**Historic Architectural Review Commission
Staff Report for Item 9**

Application Number: 18-2459

Address: #1 Whitehead Street

Installation of aluminum impact doors at front entry of the Key West Aquarium.

FRONT ENTRY DOOR TO AQUARIUM

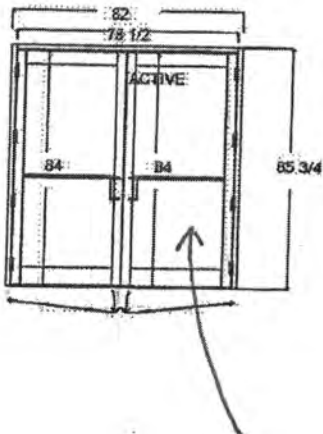
This proposal is a little unusual in that the replacement is for a door that is not the original fenestration for that part of the building, nor is it compatible with the character of the contributing building. The Secretary of the Interior’s Guidelines for Rehabilitation for Entrances and Porches and Storefronts contain very similar recommendations for “Designing the Replacement for Missing Historic Features.” The Entrances and Porches section recommends, “Designing and installing a new entrance or porch when the historic feature is completely missing or has been previously replaced by one that is incompatible. It may be an accurate restoration based on documentary and physical evidence...or it may be a new design that is compatible with the size, scale, *material*, and color of the historic building” (Emphasis added) (Page 112). That section is clear in that the replacement feature should match the style and material of the historic feature. While it would be difficult for the applicants to convert the door back to a window due to current use, it is recommended that they install doors (such as a wood, half glazed French door) that more accurately reflects the character of the original windows.

Therefore, staff finds the proposal inconsistent with the guidelines, the Secretary of the Interior's Standards, and the Secretary of the Interior's Guidelines for Windows, Entrances and Doors, and Storefronts.
